REVISED  
ENVIRONMENTAL  
IMPACT STATEMENT

for  
HALAWA MEDIUM  
SECURITY FACILITY

prepared for:  
Department of Accounting & General Services

prepared by:  
Wilson Okamoto & Associates, Inc.

fig.4 Preliminary Grading Plan

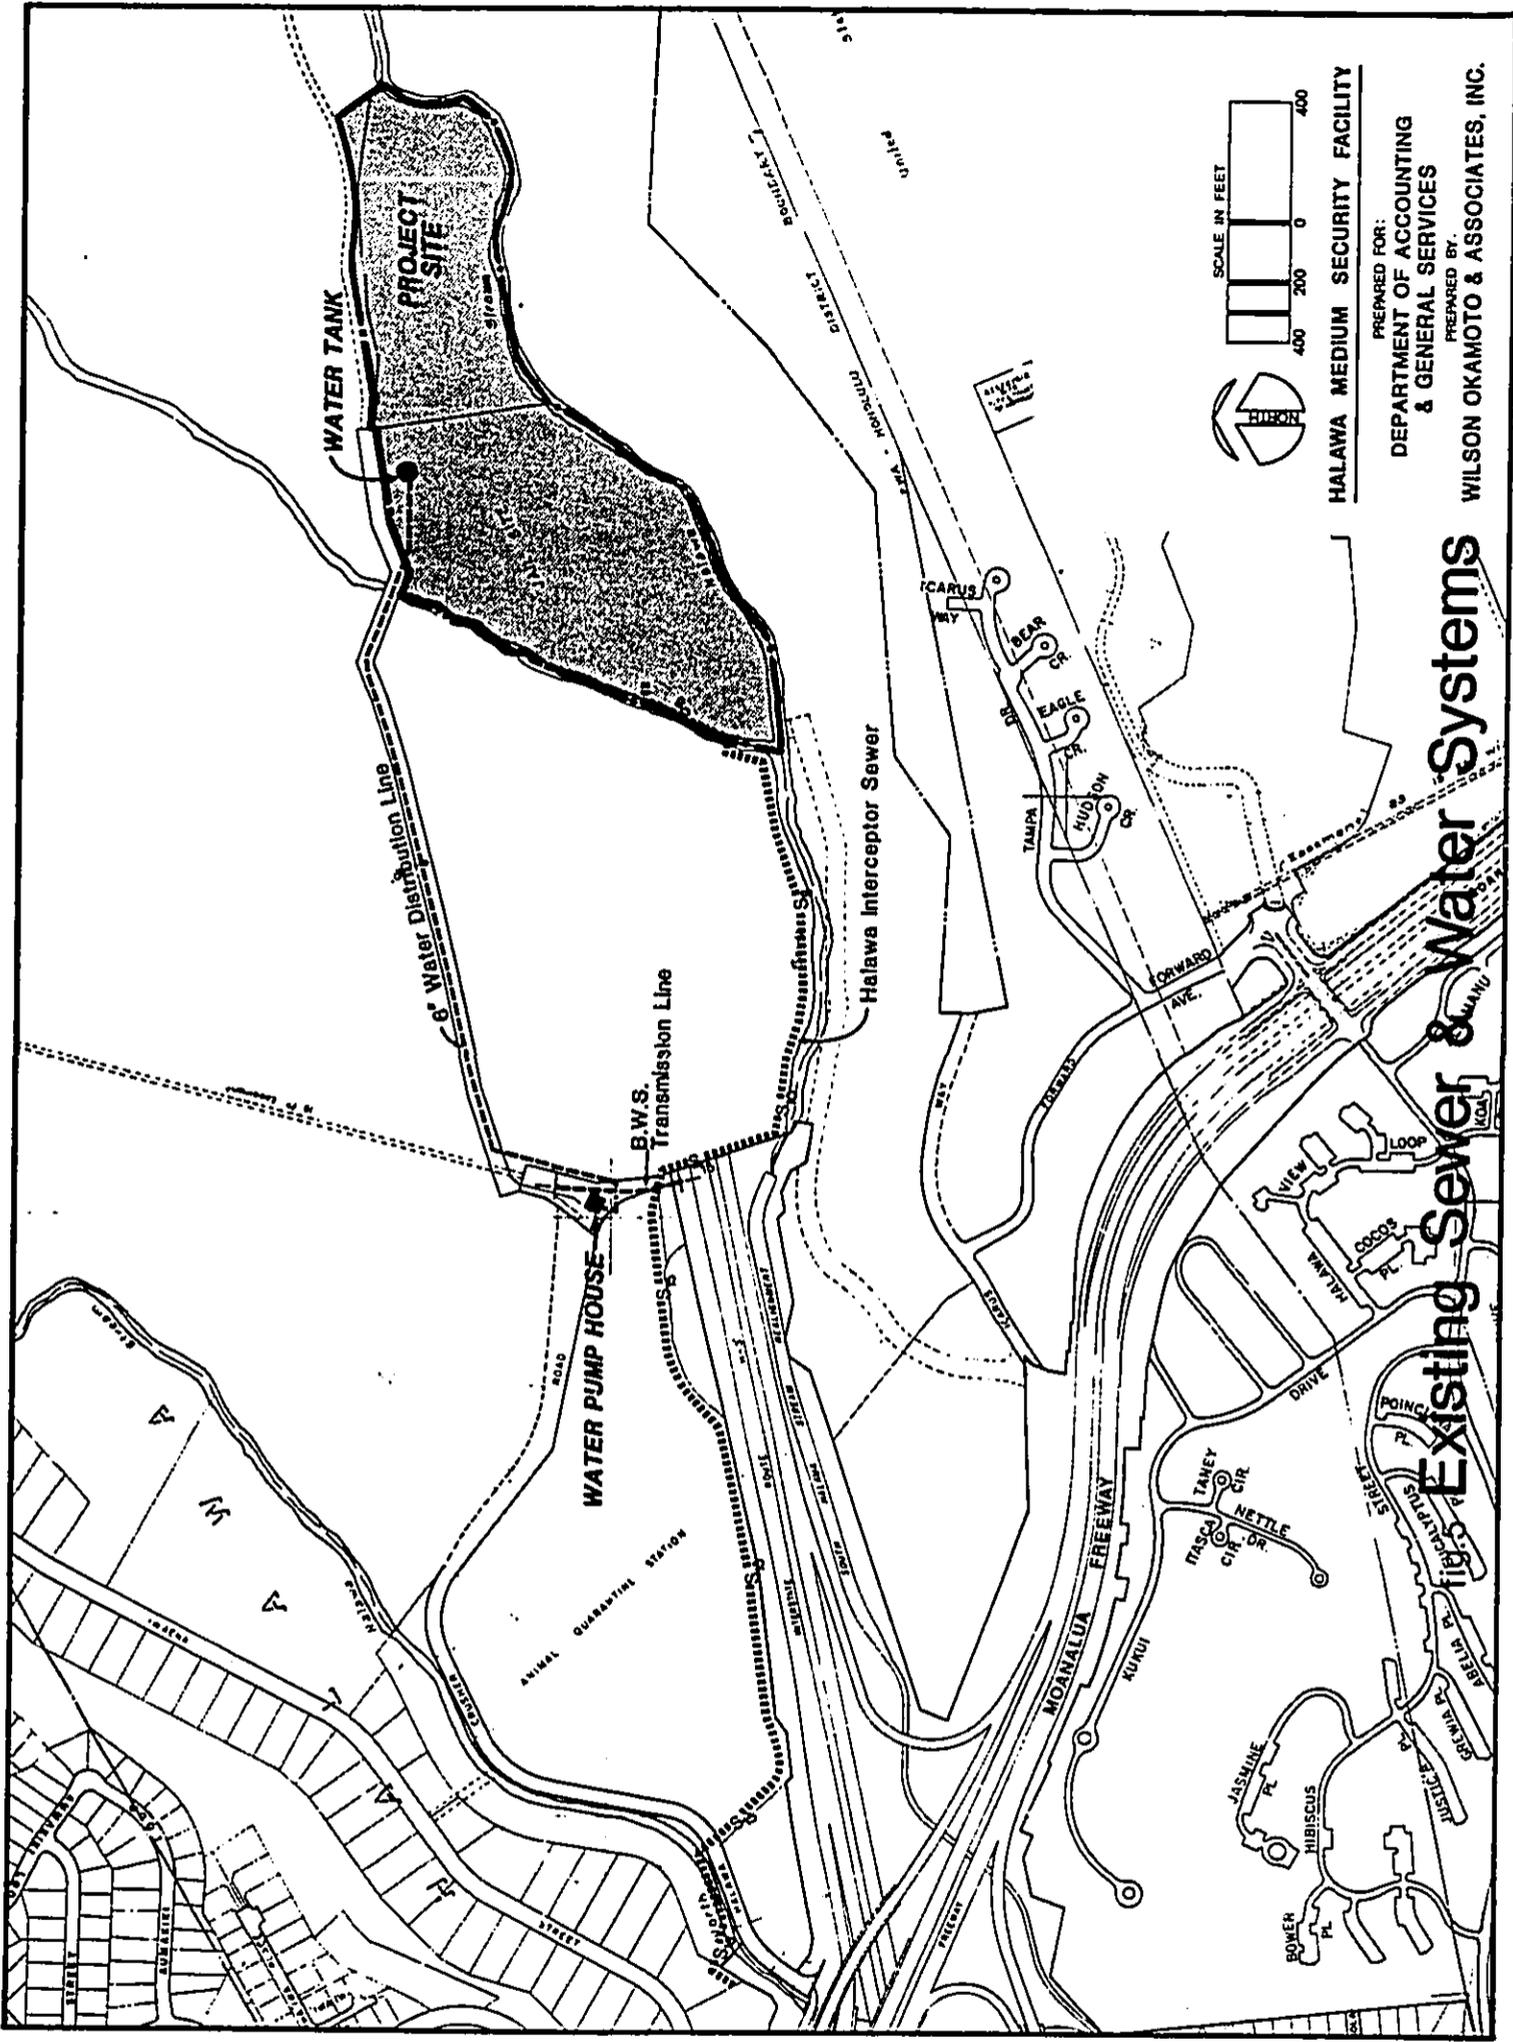
1. Comment: A finished topography map should be presented, specifying approximate amounts of required excavation and embankment.

Response: A preliminary grading plan with preliminary earthwork quantities will be incorporated into the EIS.

fig.7 Preliminary Drainage Plan

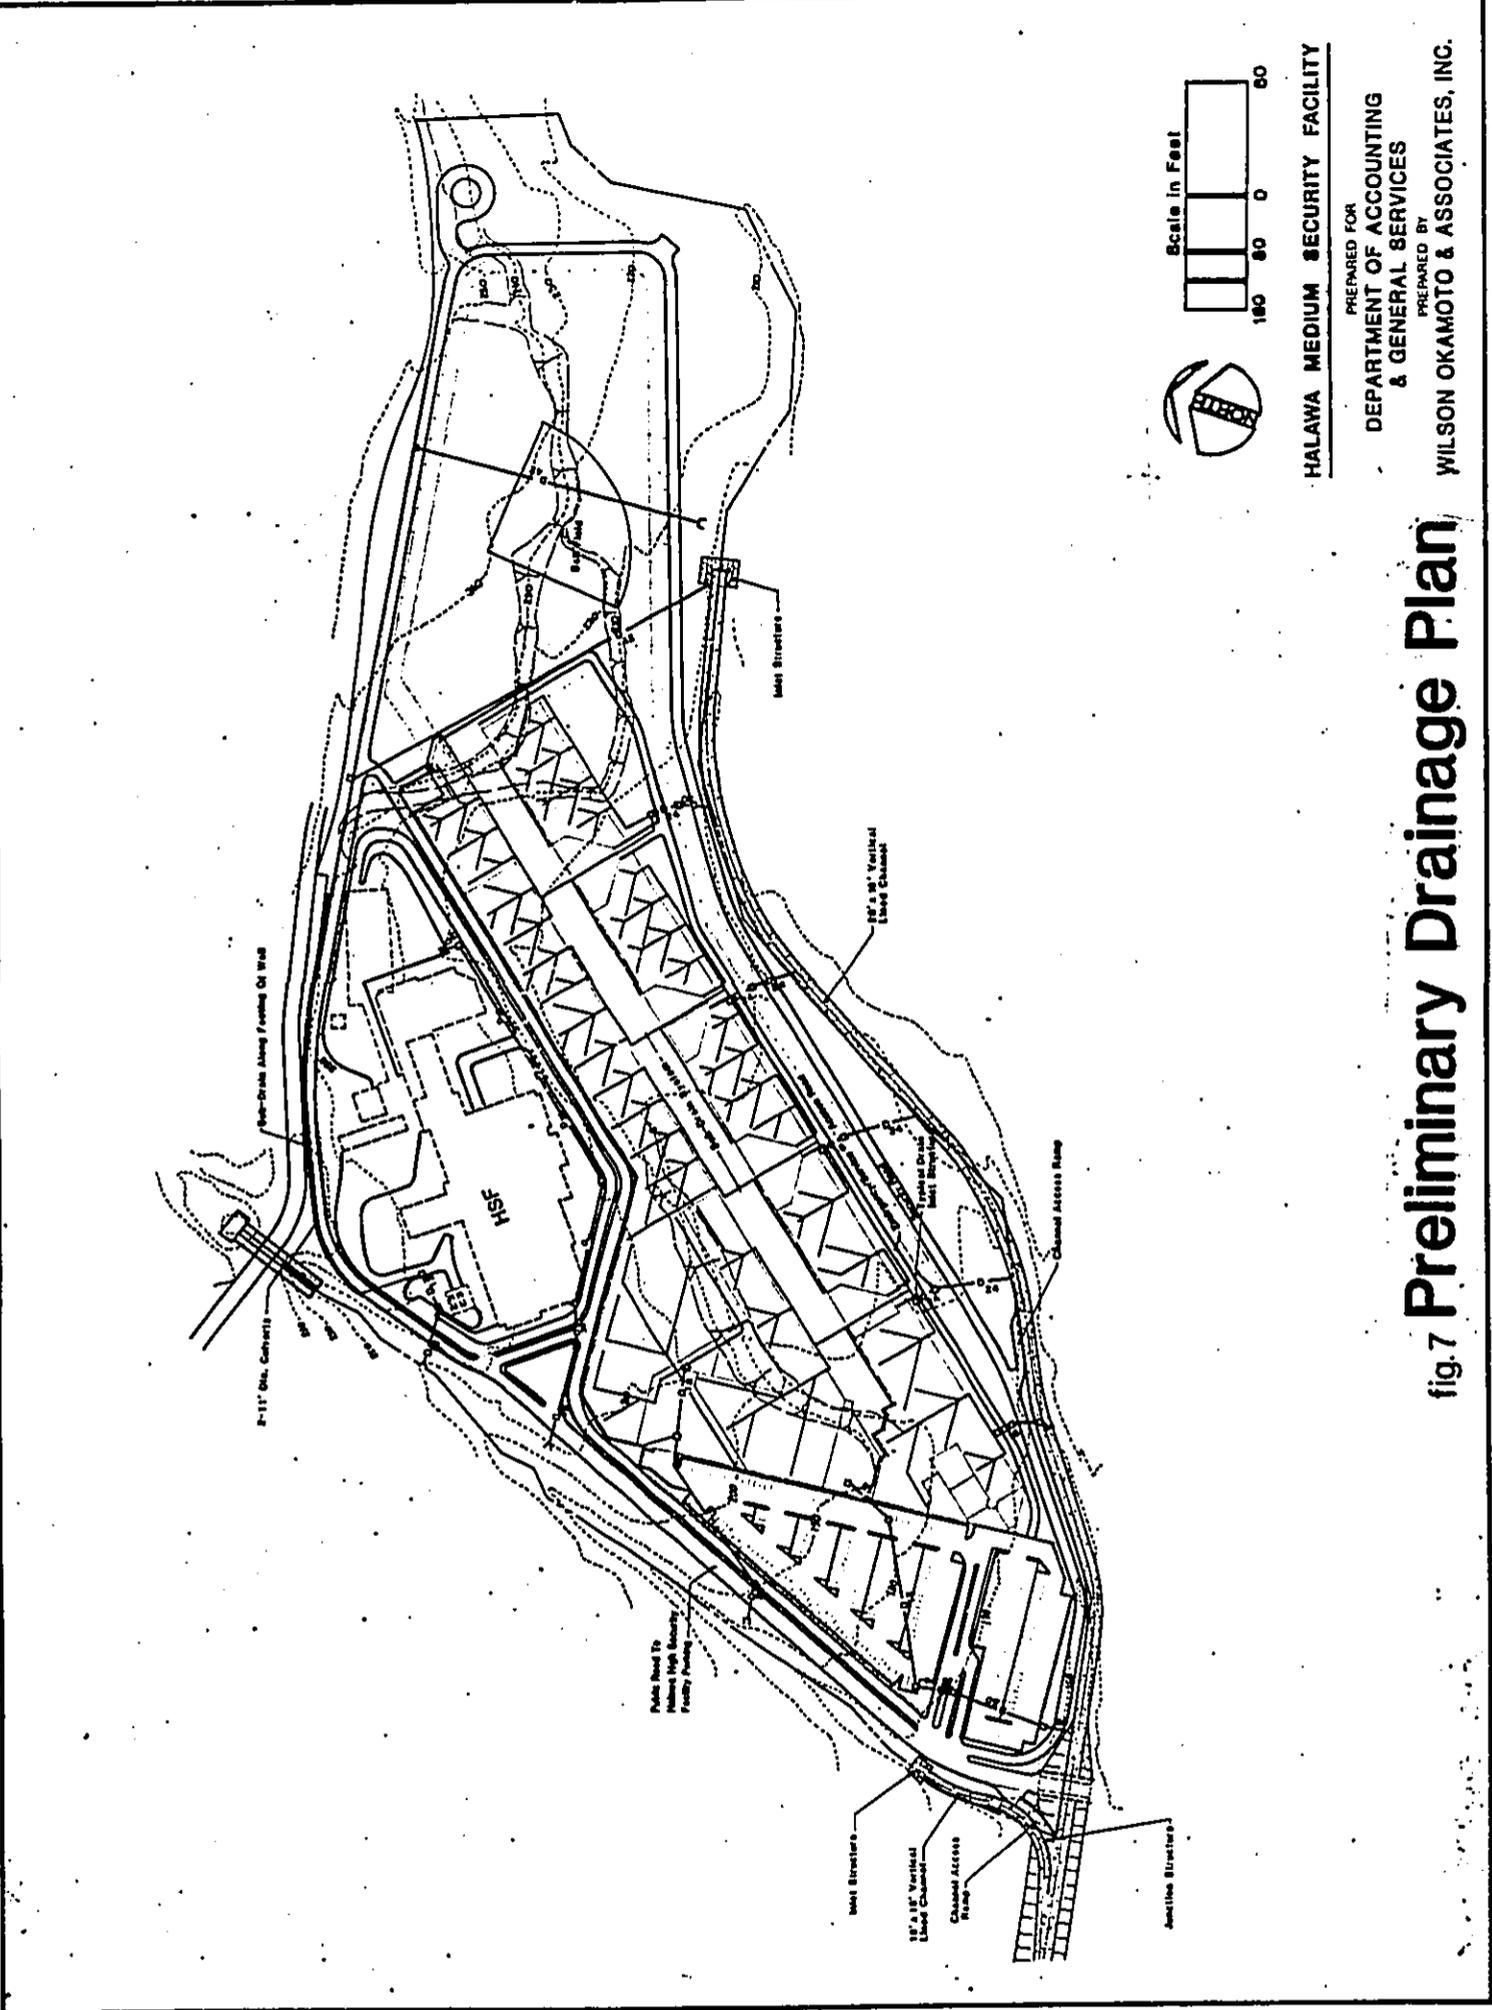
2. Comment: A preliminary drainage plan should be presented, showing proposed improvements and directions of flows.

A preliminary drainage plan will be included in the revised EIS to more clearly describe the proposed improvements.

Response: A preliminary drainage plan will be incorporated into the EIS.

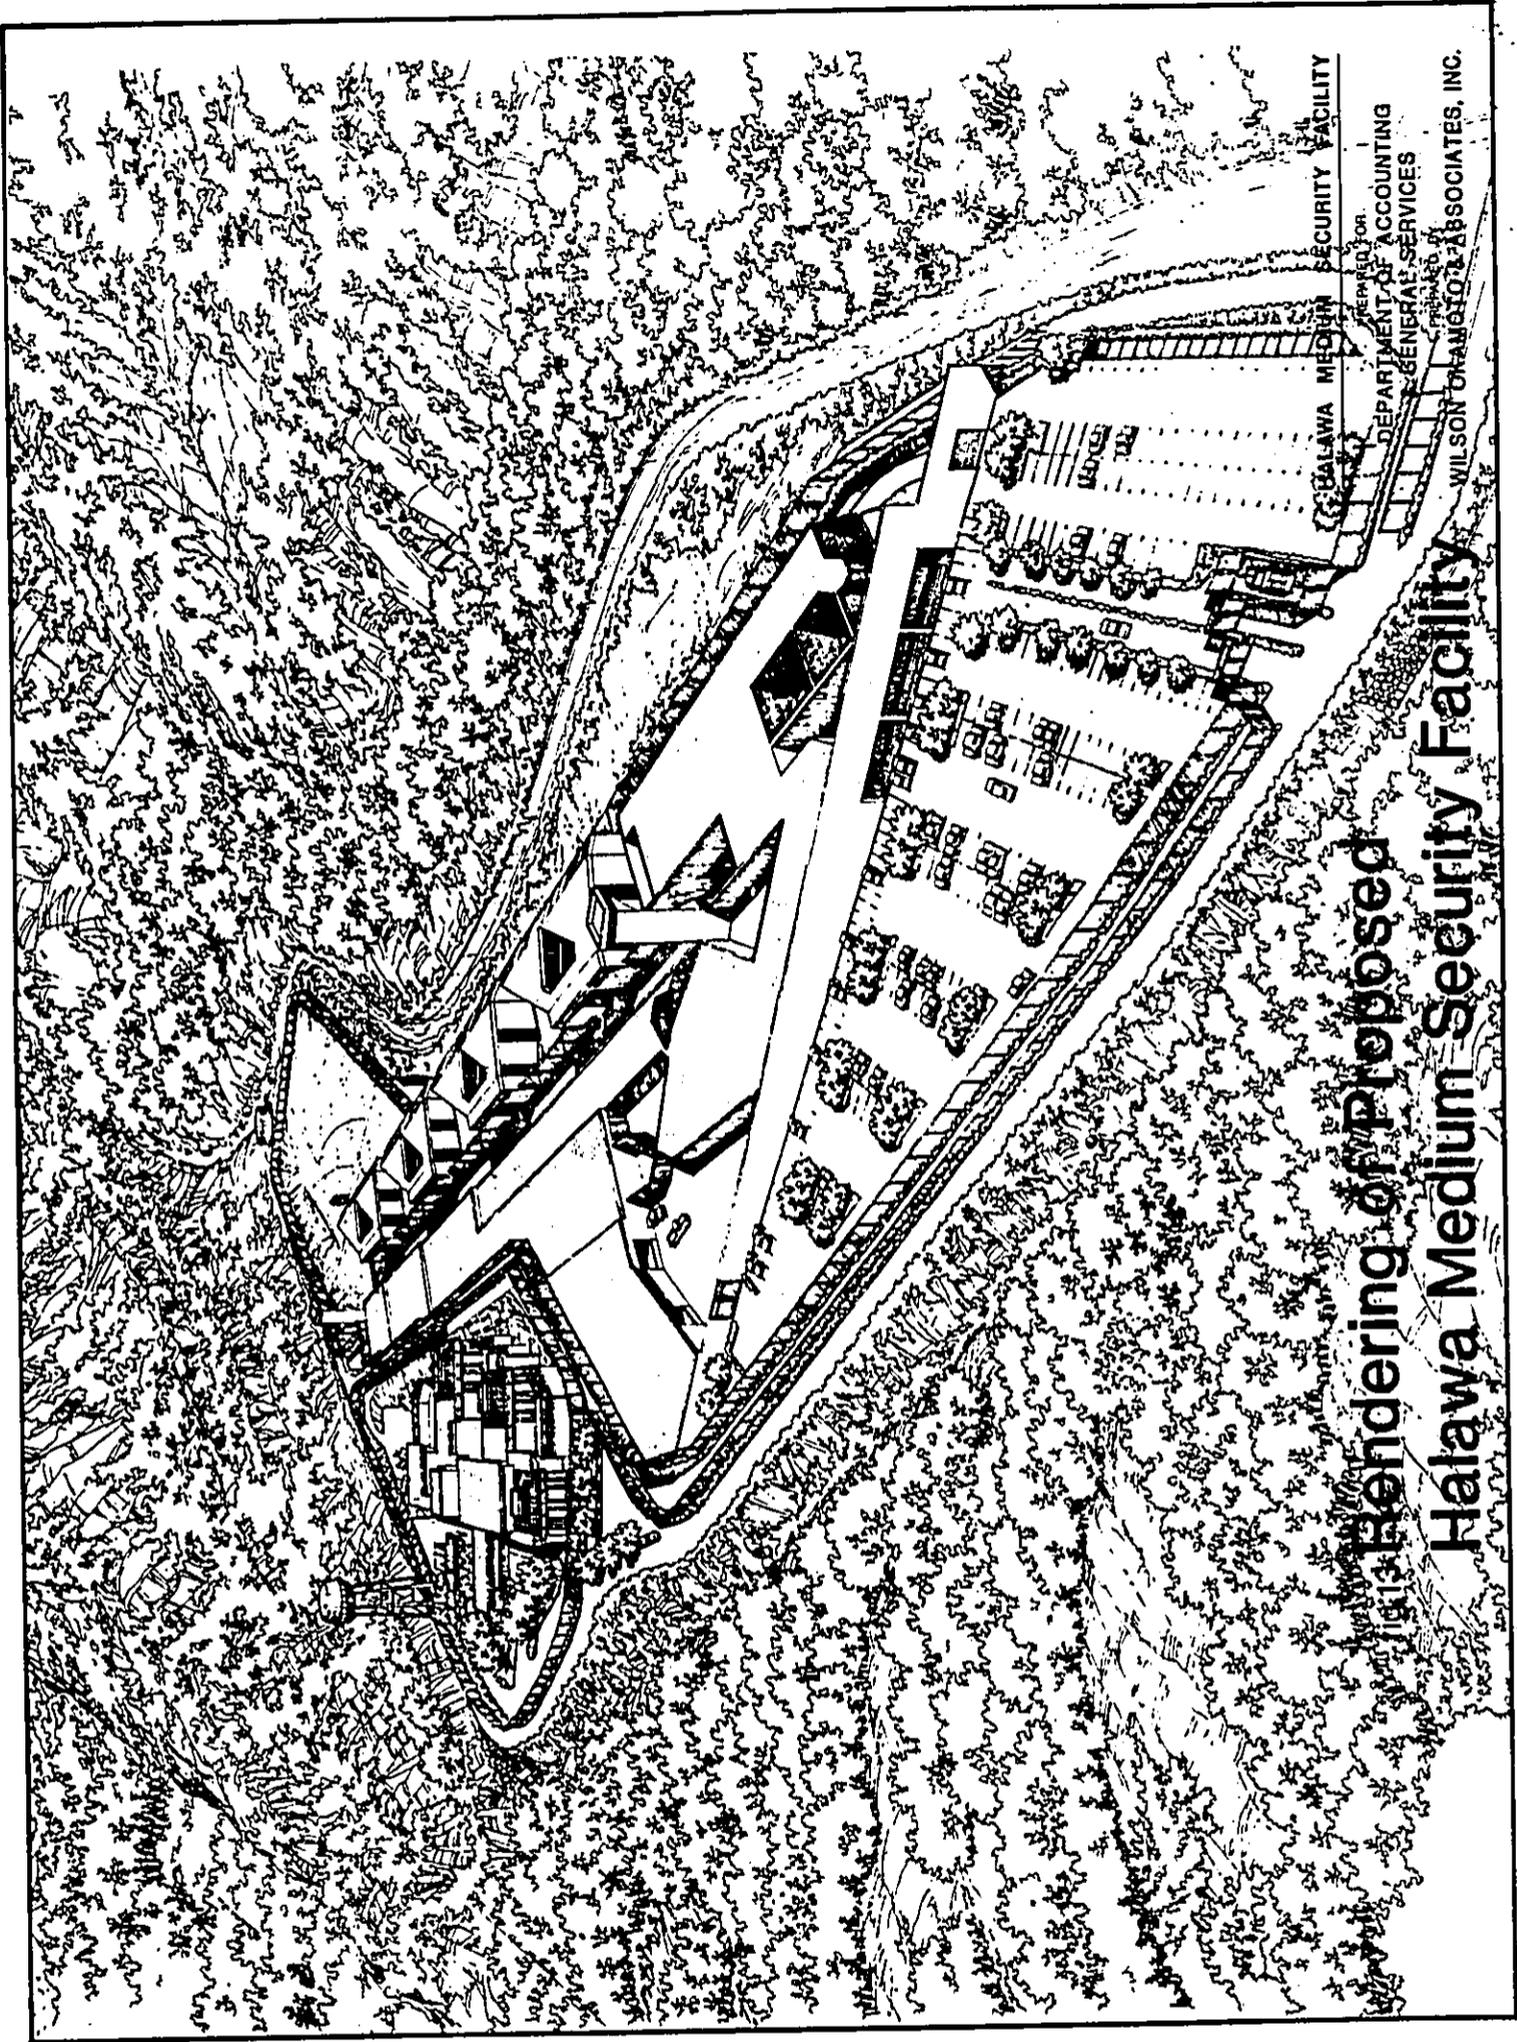
5. Comment: A rendering or elevation of the proposed medium security facility in relationship to the project site and the existing high security facility would be useful in the discussion of the visual impacts.

Response: A rendering will be incorporated into the EIS.
